APPLICATION NO.	FILING DATE	FIRST NAMED INVENTOR	ATTORNEY DOCKET NO.	CONFIRMATION NO.
10/625,643	07/24/2003	Shinichiro Fujita	116668	9724

Office Action Summary	Application No. 10/625,643	Applicant(s) FUJITA ET AL.	
	Examiner Matthew Bradley	Art Unit 2187

DETAILED ACTION

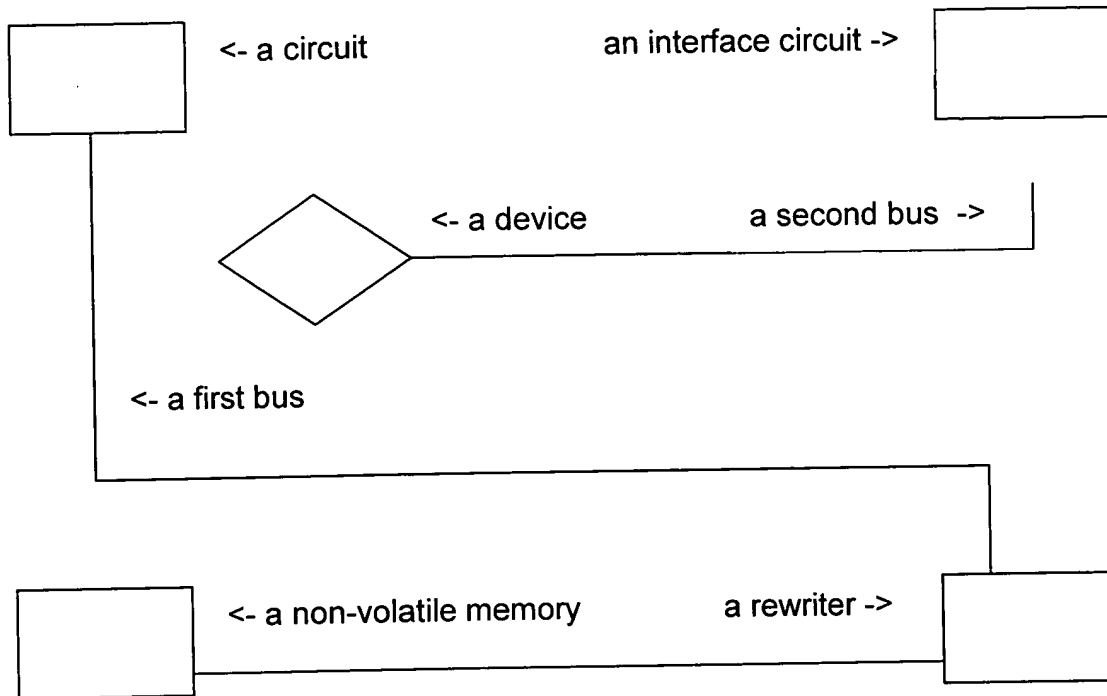
The Examiner notes that as amended, claim 1 recites, '...an interface circuit which performs interface processing with a device connected to a second bus ... a rewriter activation section which causes the rewriter to start processing when the second bus is detected to have no connection to any device.' This is indefinite. The last limitation requires the second bus to have no connection to any device, however the interface circuit performs interface processing with a device connected to a second bus. Nothing appears to be recited in the instant claim language which would allow for the disconnection of this device from the second bus to allow the rewriter to begin processing.

The Examiner would further like to illustrate, in the form of the picture shown *infra*, how the Examiner is interpreting the instant claim language in so far as it is clear:

The Examiner notes that as shown supra, the device is connected to the second bus. No other connections appear to be positively recited, although, the claim does appear to imply connections by reciting, 'data transfers through a first bus ...e.g.', clarification is respectfully requested.

Further the Examiner is also unsure how the rewriter can begin processing as no connection of the second bus to the rewriter appears to be recited; therefore how can a **dis-connect** occur to begin processing?
